## Newport Lakes Conservation & Development Plan (Draft):

### FoNL Response

Our response takes the form of direct comment on the action points proposed in Section 12 (Implementation).

#### MAIN VISITOR FACILITIES IMPROVEMENTS

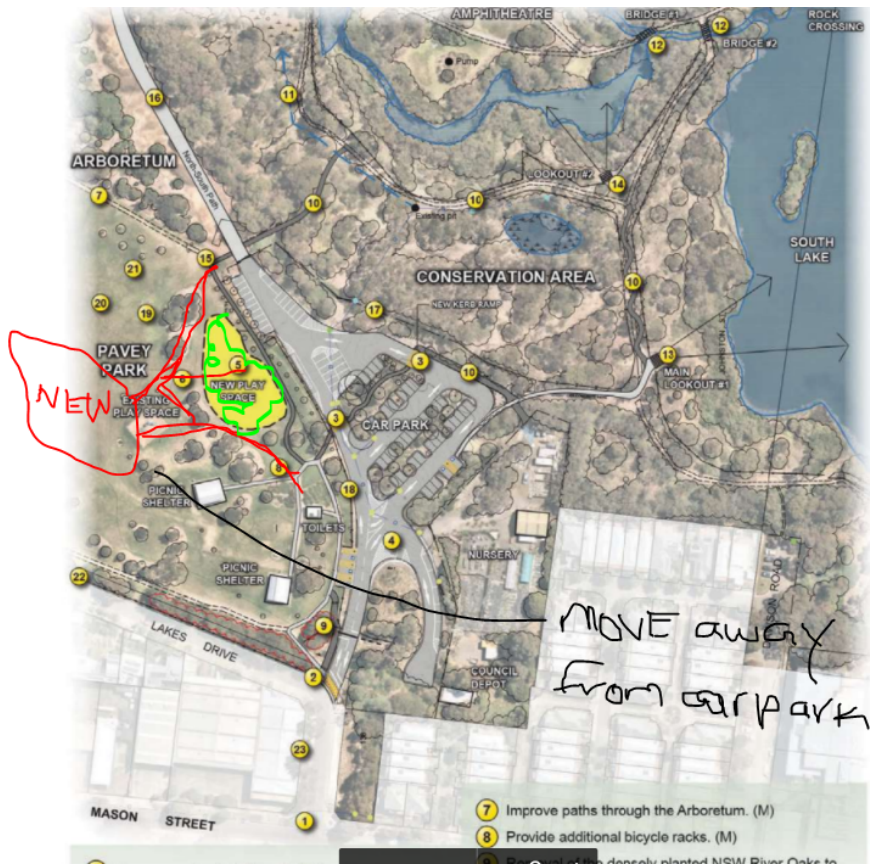
1	Support
2	Support
3	Support

4	Support
5	Support
6	Support
7	Support
8	Support
9	Support but would prefer mature trees not be removed.
10	Support
11	Support
12	Support
13	Support
14	Support
15	Support
16	Support
17	Support
18	Support
19	Support
20	See R12
21	Support
22	Support
23	Support
